Government of South Australia
Coast Protection Board

INQUIRY REPORT – WITTON BLUFF BASE TRAIL

19 April 2021

Figure 5 Witton Bluff - General Profile. Source: Integrated Coasts Pty Ltd 2020

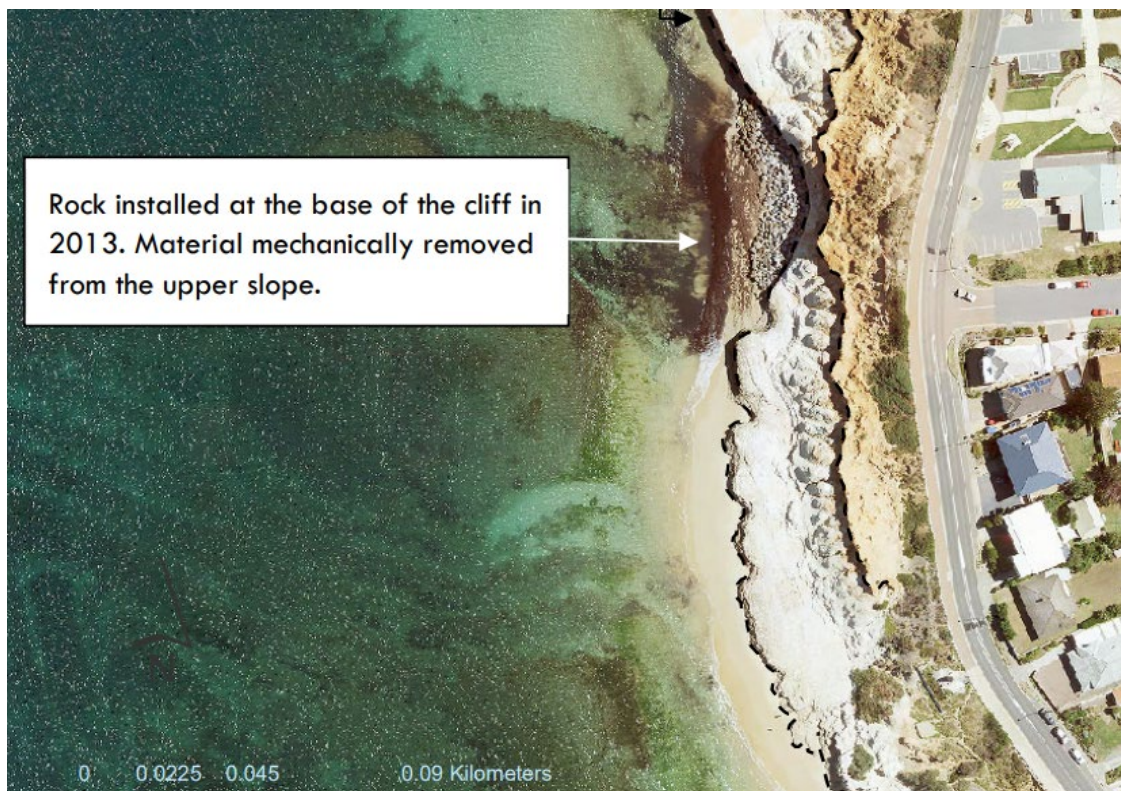
An analysis of aerial photography from 1949-2017 (Integrated Coasts Pty Ltd 2020), suggests that overall, the base of the ledge appears to be in similar position to 1949, apart from a concaved area of recession between the two limestone platforms – this area eroded approximately 2.5 metres since 1949 and this was addressed in 2013 with the placement of rock protection (Figure 5 and 6).

While historically the limestone shelf appears relatively stable and resistant to wave forces, the combination of storm surge events and elevated ocean water levels (projected sea level rise) may exacerbate erosion in the long term.
